## Development Review Division

**SUBJECT:** SP21-063; Douglas 234 F6 L1 - Gas and Convenience Store  
Review Comments 01

# CONVENIENCE STORE SITE PLAN

LOT 1 OF DOUGLAS 234 FILING NO. 6

### 1 LANDSCAPE PLAN

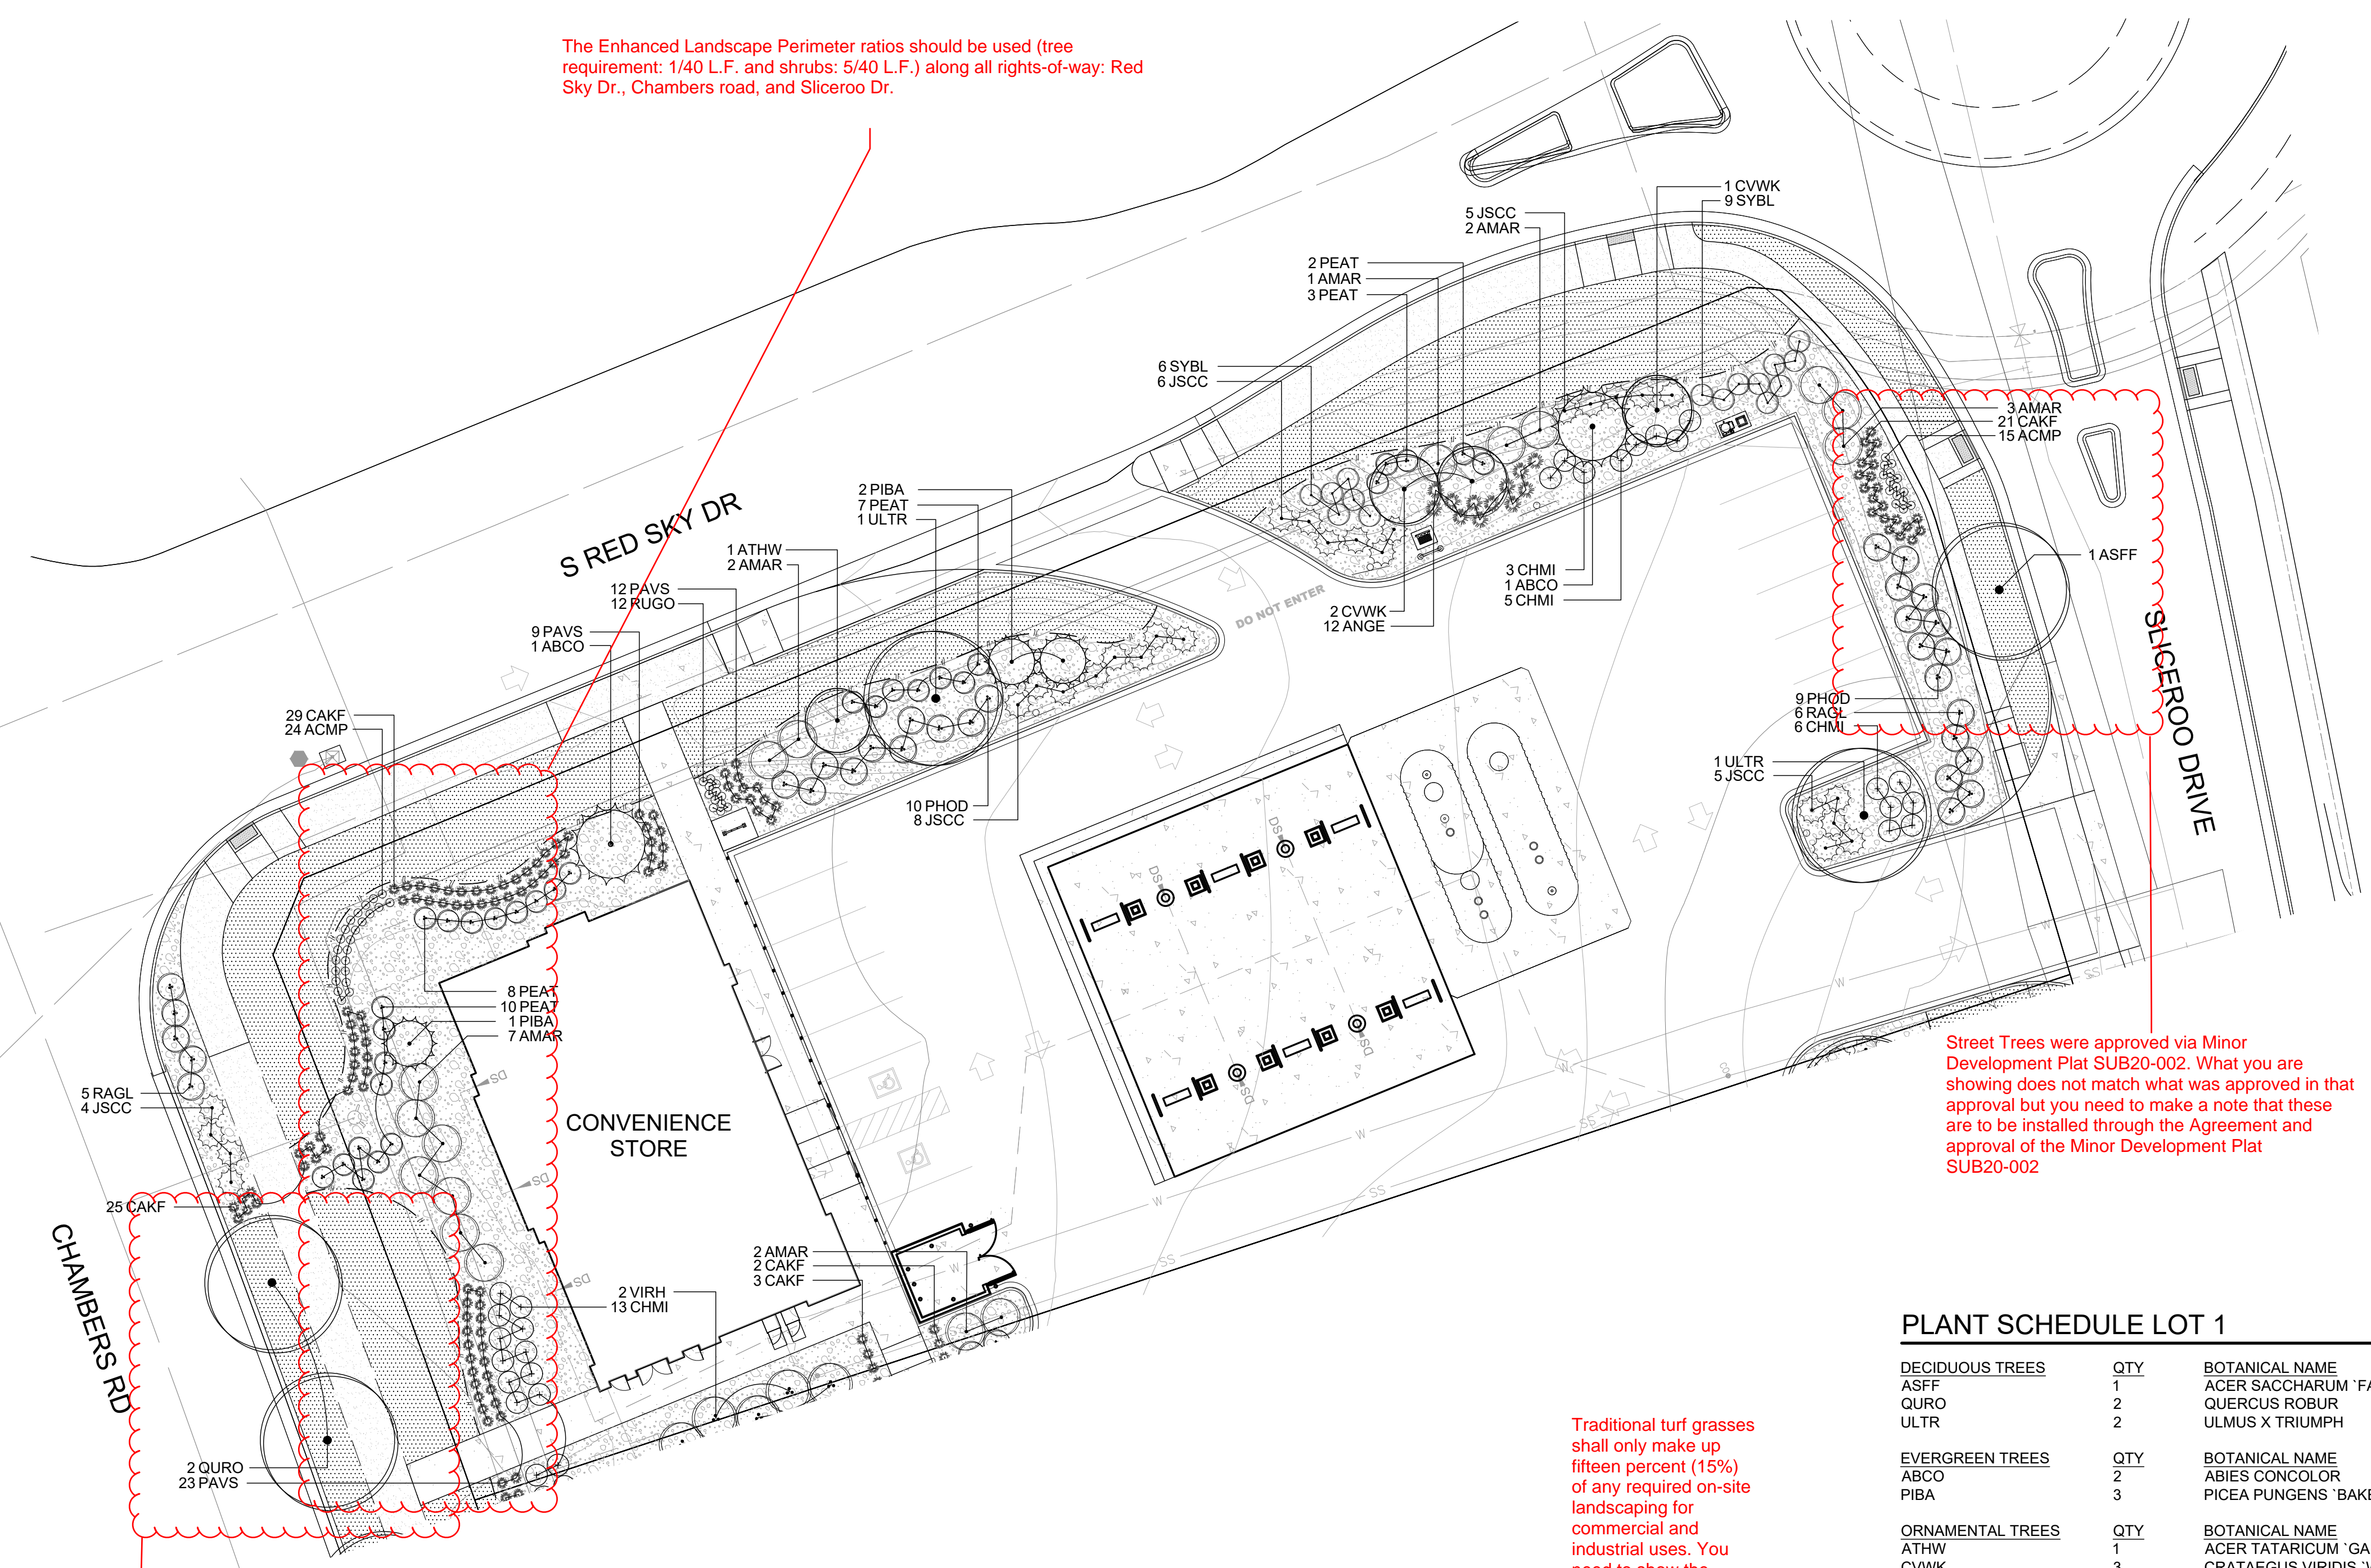
The Enhanced Landscape Perimeter ratios should be used (tree requirement: 1/40 L.F. and shrubs: 5/40 L.F.) along all rights-of-way: Red Sky Dr., Chambers road, and Sliceroo Dr.

Street Trees were approved via Minor Development Plat SUB20-002. What you are showing does not match what was approved in that approval but you need to make a note that these are to be installed through the Agreement and approval of the Minor Development Plat SUB20-002

Traditional turf grasses shall only make up fifteen percent (15%) of any required on-site landscaping for commercial and industrial uses. You need to show the Percentage and compliance.

Include Maturation Heights

- Call out for size to show how you get 15%
- Break out the required Streetscape Landscaping no further that 1 tree ever 40' apart
- Need to break out Parking Lot Perimeter Landscaping
- See example chart provided on referral notes.
- Math needs to be shown for all calcs. of how you get to the required percentages

Street Trees were approved via Minor Development Plat SUB20-002. What you are showing does not match what was approved in that approval but you need to make a note that these are to be installed through the Agreement and approval of the Minor Development Plat SUB20-002

**WEST ELEVATION**

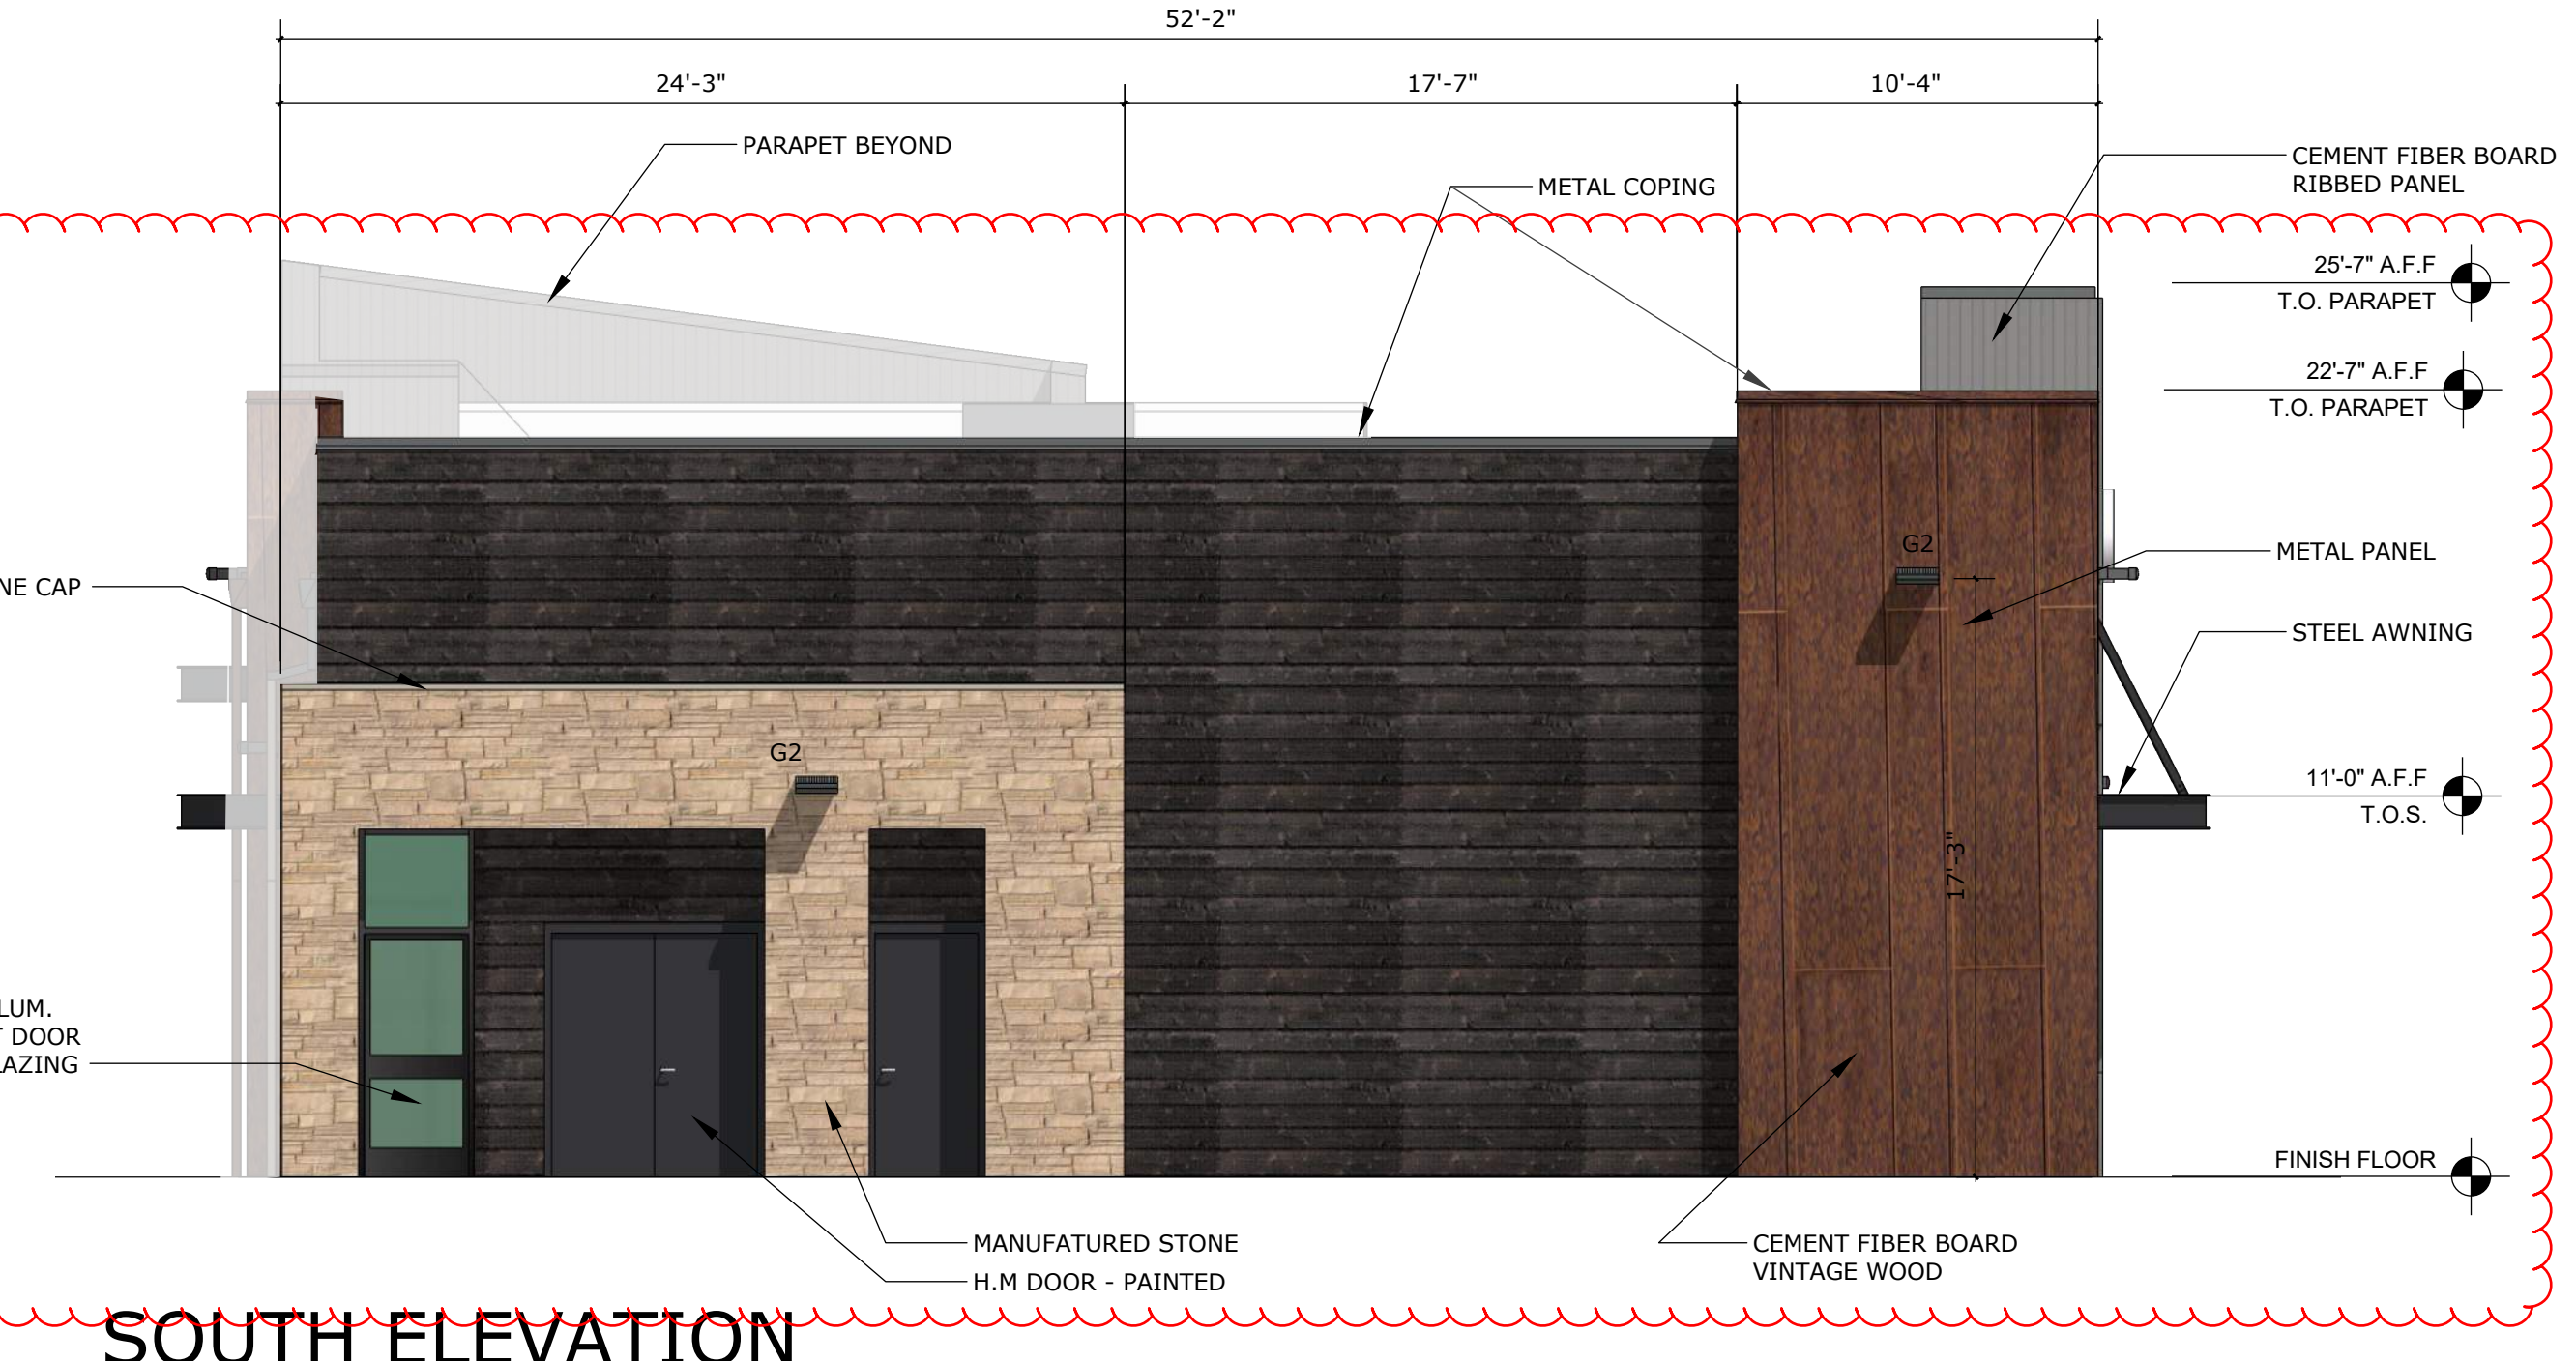
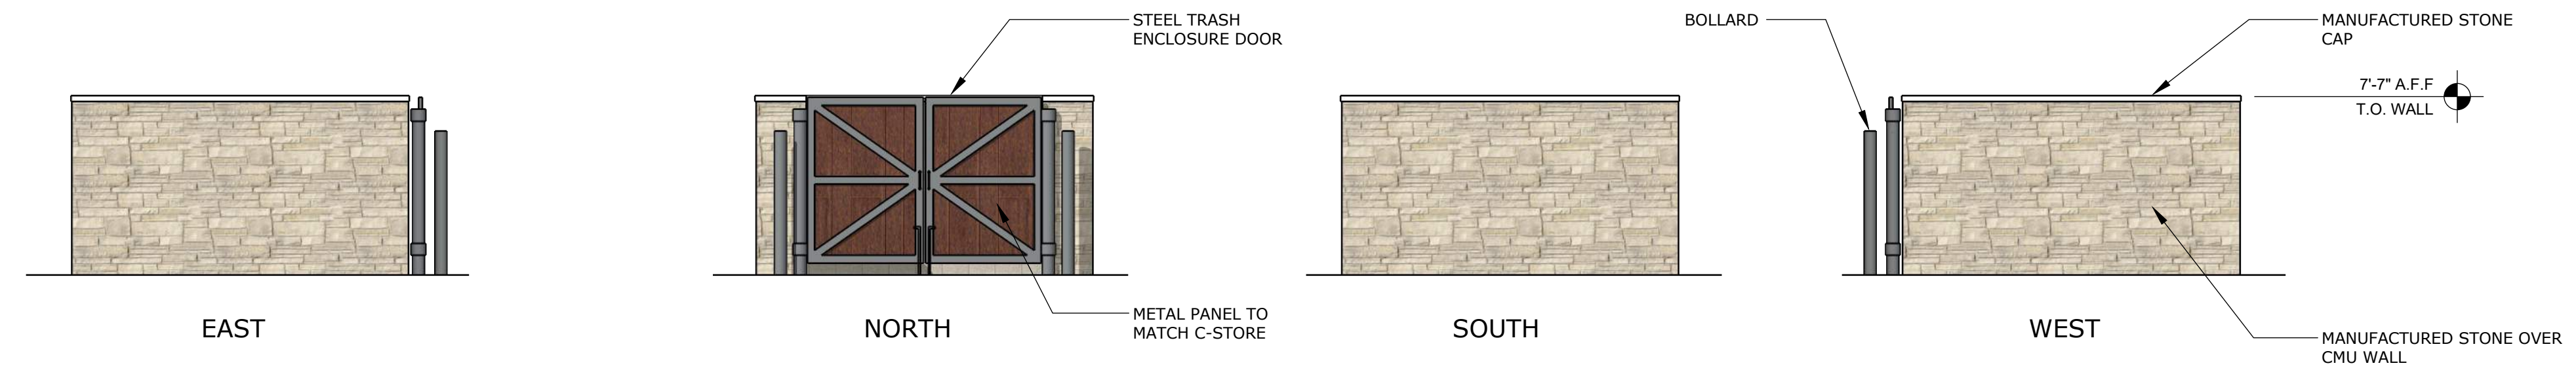
Please work out the math for me here. When I do the calcs. I get a similar number based on your dimensions for the mural but almost 50 sf difference for the windows. The window appears to be dimensions at 5'-0" by 24'-10" which = 124.165 sf, not 214 as shown below? I think it may be you are not showing 2 additional feet of window under the awning?

Where are you getting 961 from?

How are you meeting 25% transparency requirements?

Where/how are you getting 792 from-show calc?

Please note on all relevant sheets that signage is a place holder and will be obtained under separate permit.
